TITLE	PARTIAL MEZZANINE/LOW ROOF FRAMING PLAN - AREA B (SEQ-1)		
MADE BY	DATE	CONTRACTOR	JOB No.
PDS	11/30/2020		20028
CHKD BY	DATE	ARCHITECT	ENGINEER
JSY	11/30/2020		
			SHEET NO.
			1E1
			REV.
			A

**PARTIAL MEZZANINE/LOW ROOF FRAMING PLAN @ AREA-B (SEQ-1)**  
 (REF: S2.2 & 1/A1.3)  
 [TOP OF STEEL ELEVATION 114'-0 1/2" U.N.O.]

1-1  
1E1  
(REF: 5/S4.2)  
(OTHER INFO NOT SHOWN FOR CLARITY)

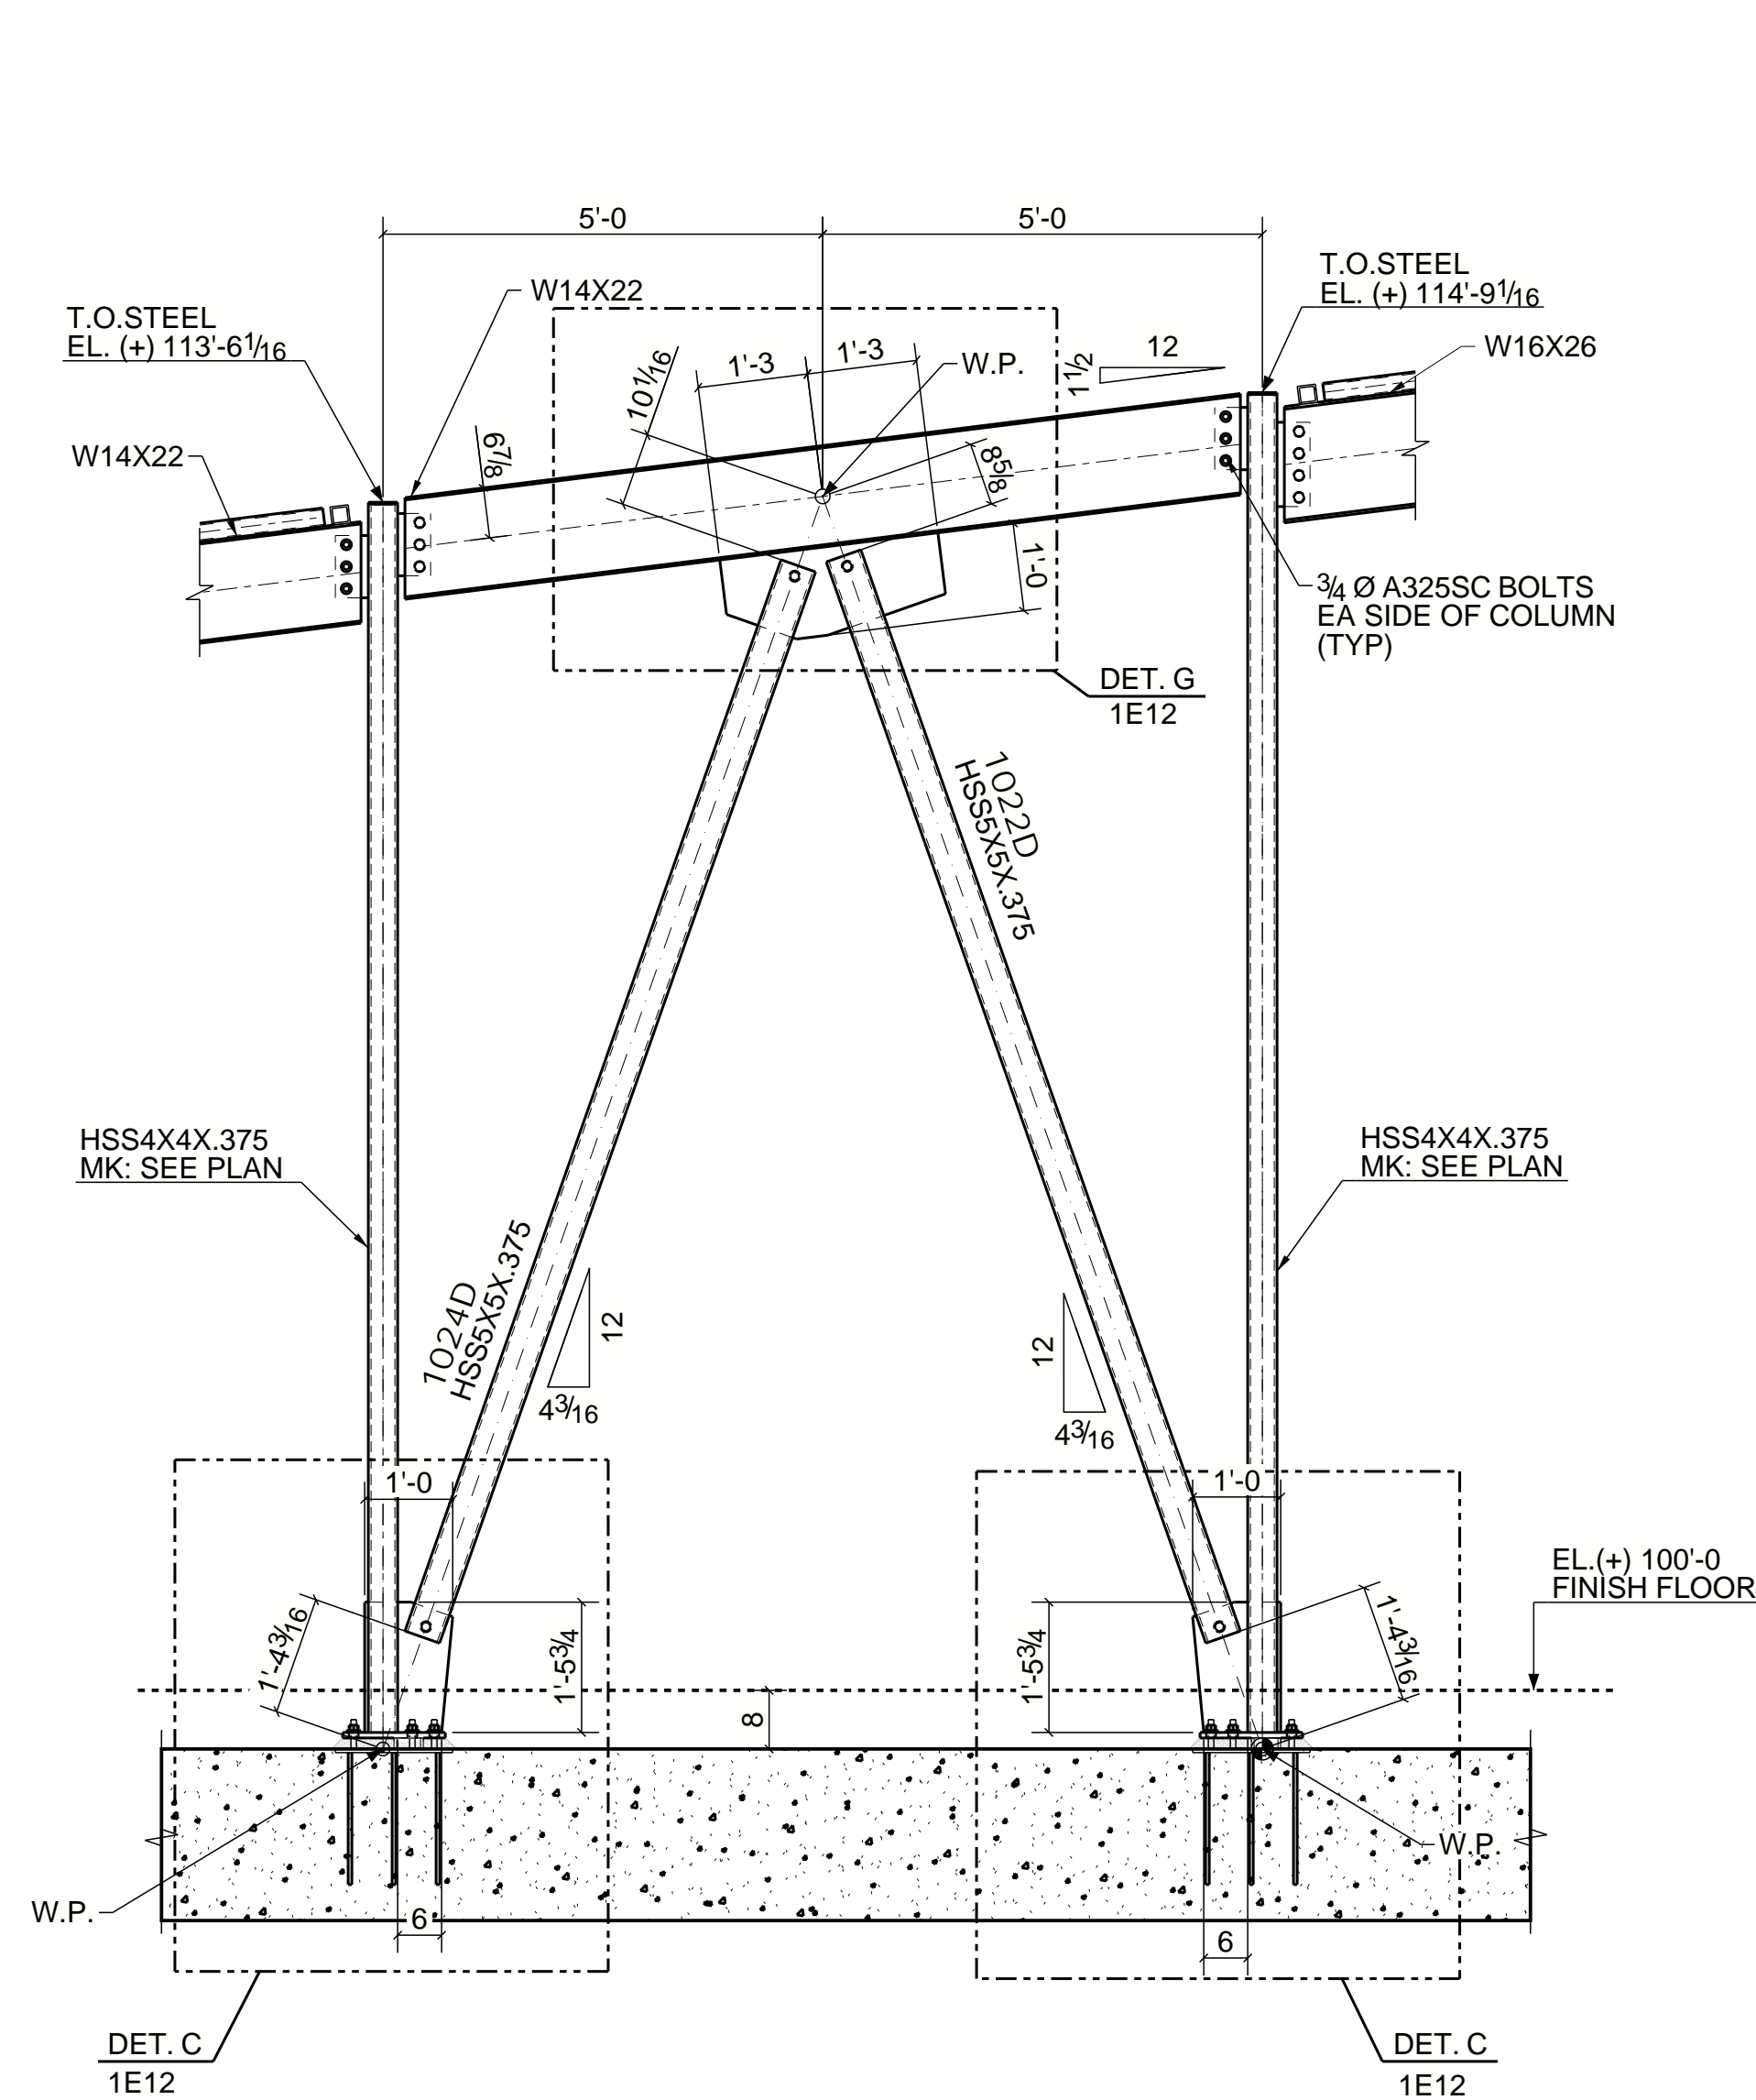
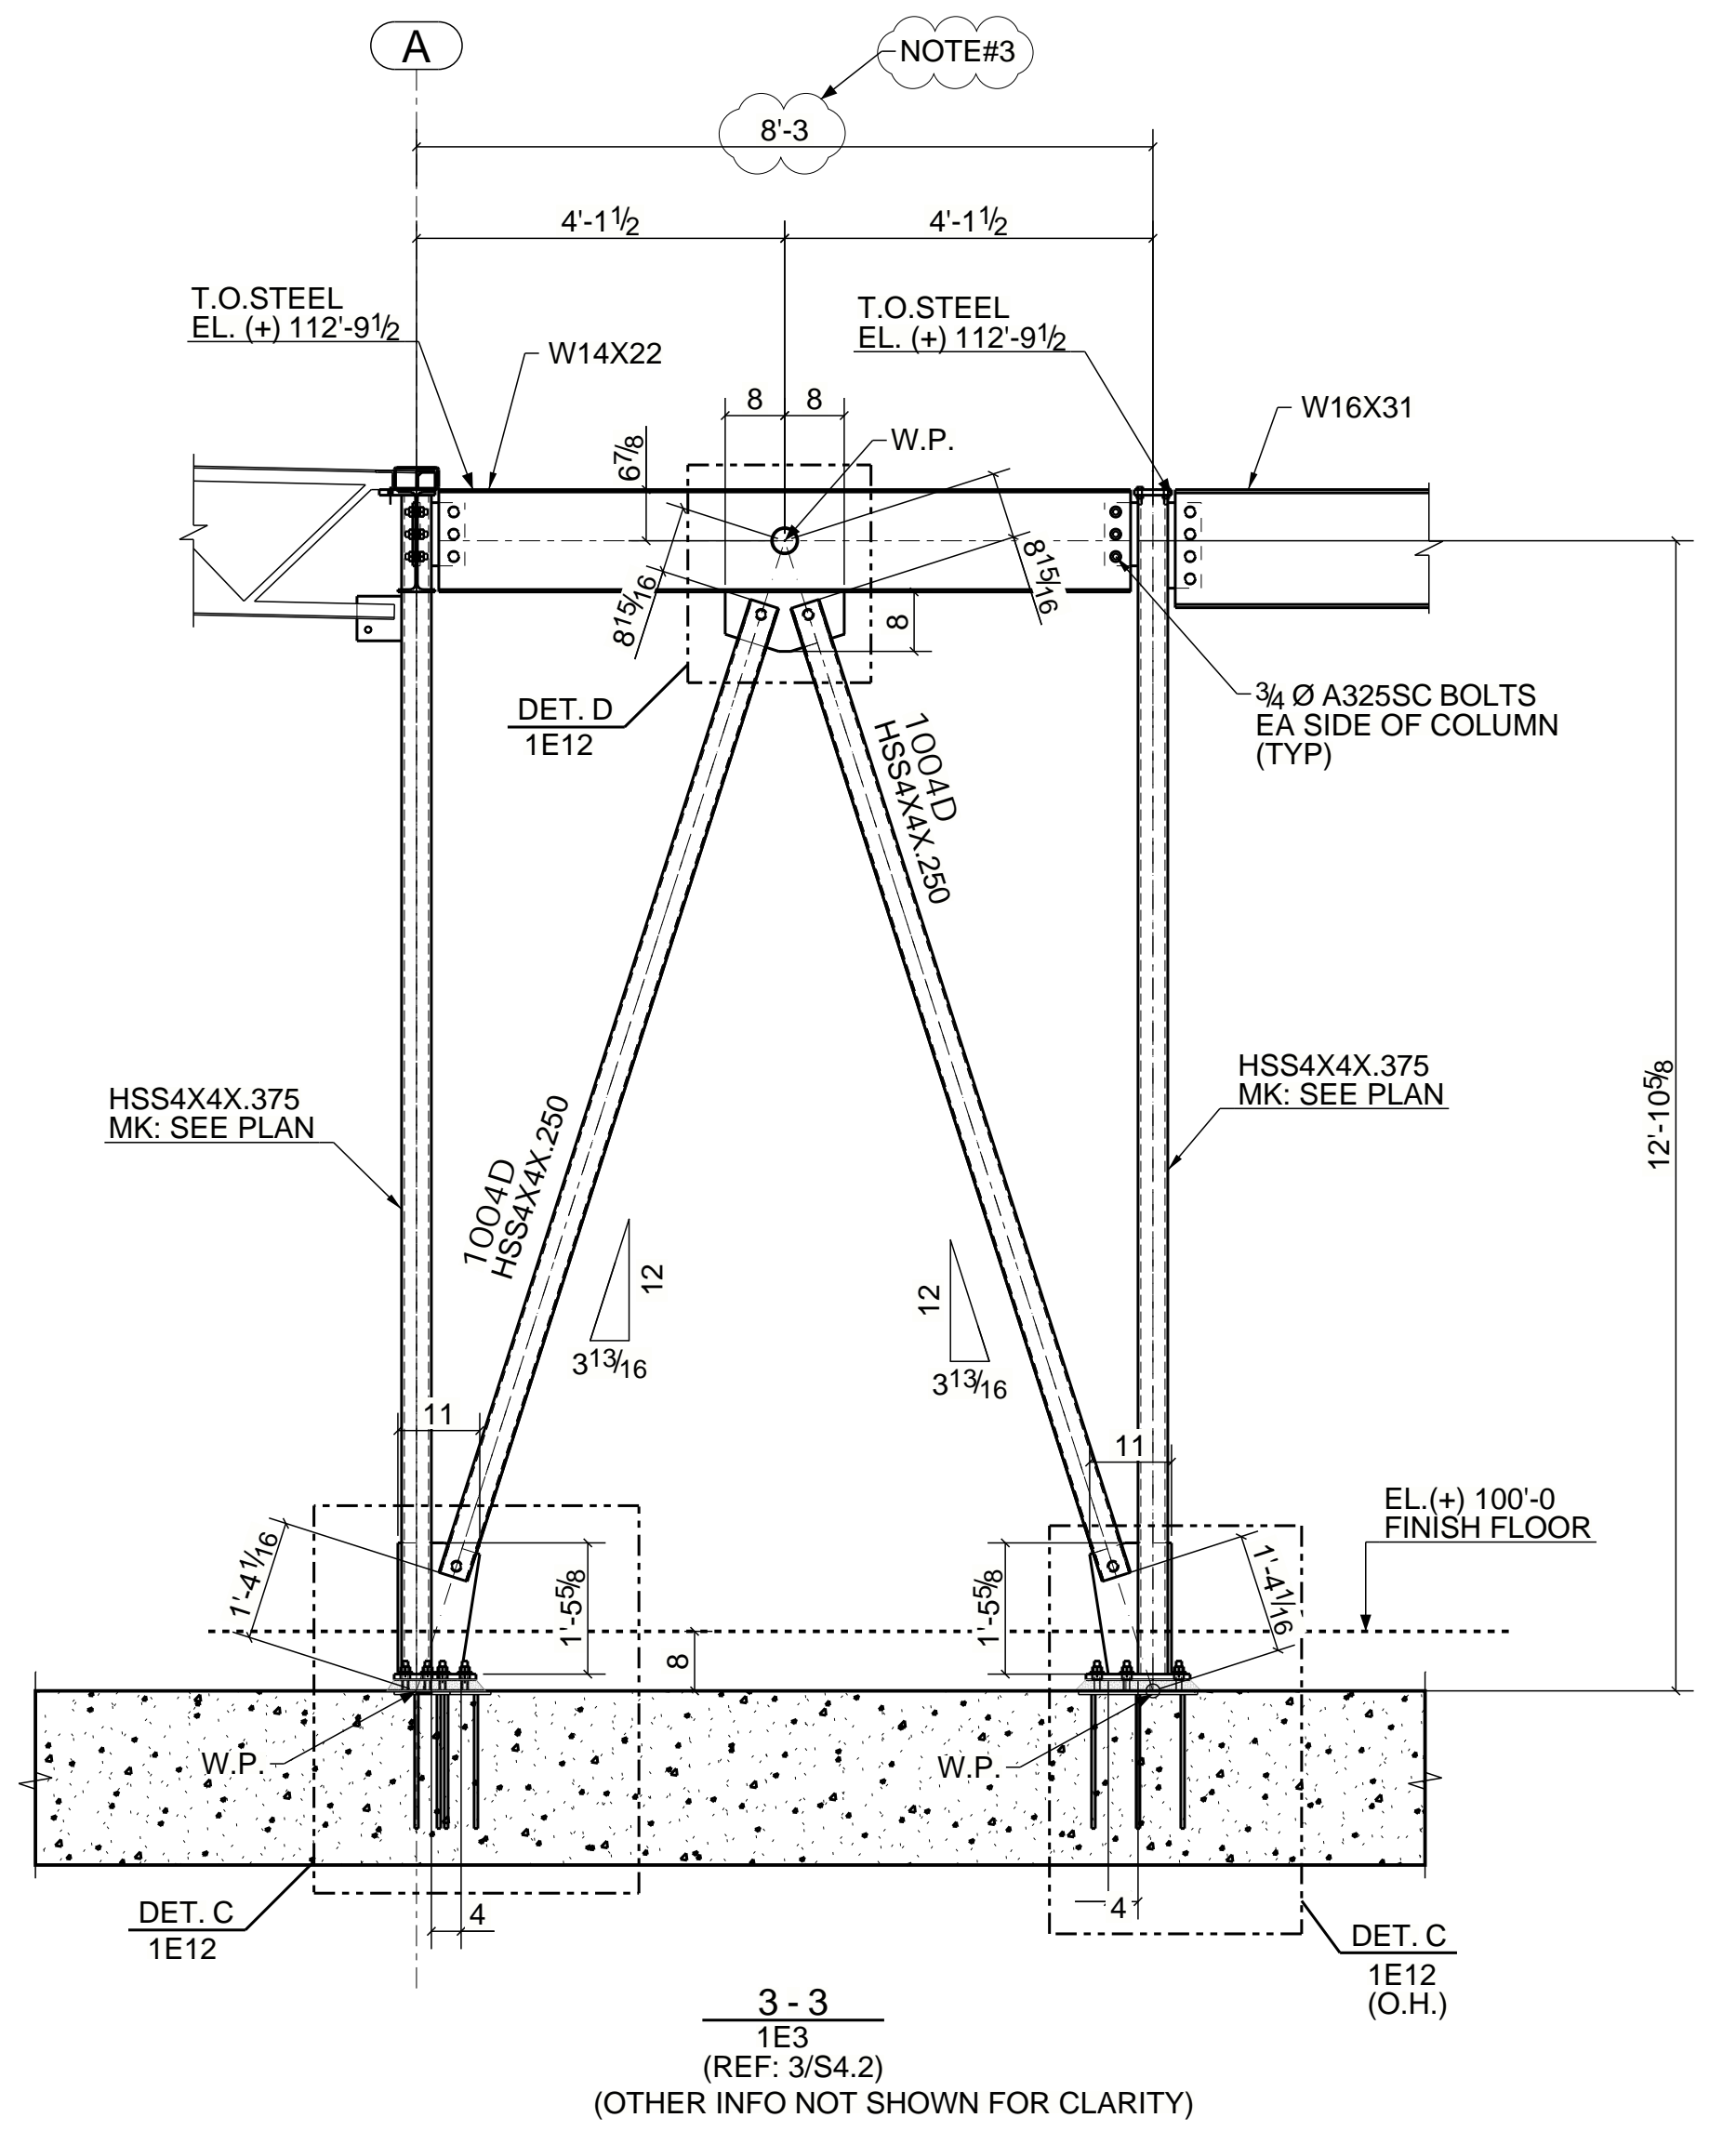
NOTES#1:- REFER STRUCTURE DRAWING S4.2, BRACE ELEVATION 5/S4.2 SHOWS BASE CONNECTION MARK "29A" AND CONNECTION MARK 29A/(2/S6.2) SHOWS BASE PLATE DETAIL BP10. BASE PLATE BP10/(2/S6.1) SHOWS BASE PLATE LENGTH 1'-1". WHILE AS PER CONNECTION 29A GUSSET PLATE WELD LENGTH AT BASE PLATE IS 1'-0", SO WE HAVE INCREASED THE BASE PLATE LENGTH FROM 1'-1" TO 1'-8". PLEASE VERIFY/SUGGEST. ALSO PLEASE SUGGEST DO WE NEED TO INCREASE THE EMBD PLATE SIZE AND AND SHIFTED 3/4" THRD STUD ACCORDING TO BASE PLATE LENGTH, AT ALL OTHER LOCATIONS ALSO IN THIS PROJECT?

NOTE#2:- WE HAVE INCREASED GUSSET PLATE SIZE TO MAINTAIN 4" WELD LENGTH OF BRACE TO GUSSET PLATE. PLEASE VERIFY/SUGGEST.

NOTE#3:- THERE IS CONFLICT IN COLUMN LOCATING DIMENSION. STRU PLANS2.2 SHOWS THIS COLUMN IS LOCATED AT 8'-3" FROM GRID LINE-A. BUT BRACE DETAIL 3/S4.2 SHOWS THIS COLUMN IS LOCATED AT 8'-3 1/2". CURRENTLY WE HAVE FOLLOWED 8'-3" PER PLAN S2.2. PLEASE VERIFY/SUGGEST.
